PJM Manual 12:
Balancing Operations

Revision: 37

Revision 37 (xx/xx/2017)

- [Revisions to Section 3.1.2 PJM Control Implementation and Section 4: Providing Ancillary Services: Incorporation of RMISTF Solution Package](#)

Exhibit 3: PJM Regulation Signals

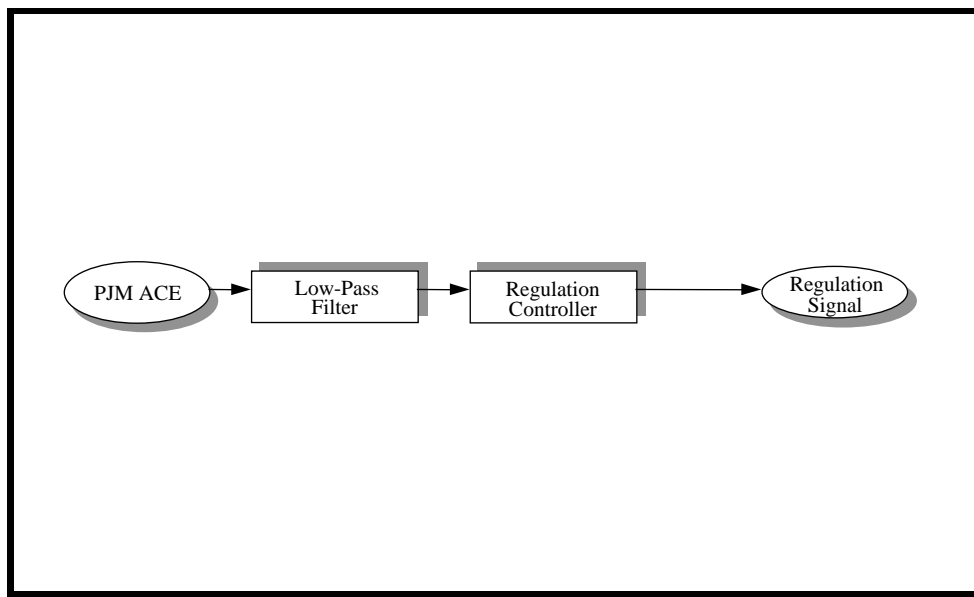
- o RegA- is the low-pass filter of the regulation control signal, developed with consideration to minimize accelerated ramp rate, sent to traditional regulating resources
- o RegD- is the residual of the regulation control signal, developed with consideration to minimize net energy demands, sent to dynamic regulating resources
- ~~RegA- low pass filter of ACE for traditional regulating resources, and,~~
- ~~RegD- high pass filter of ACE for dynamic or fast response resources~~
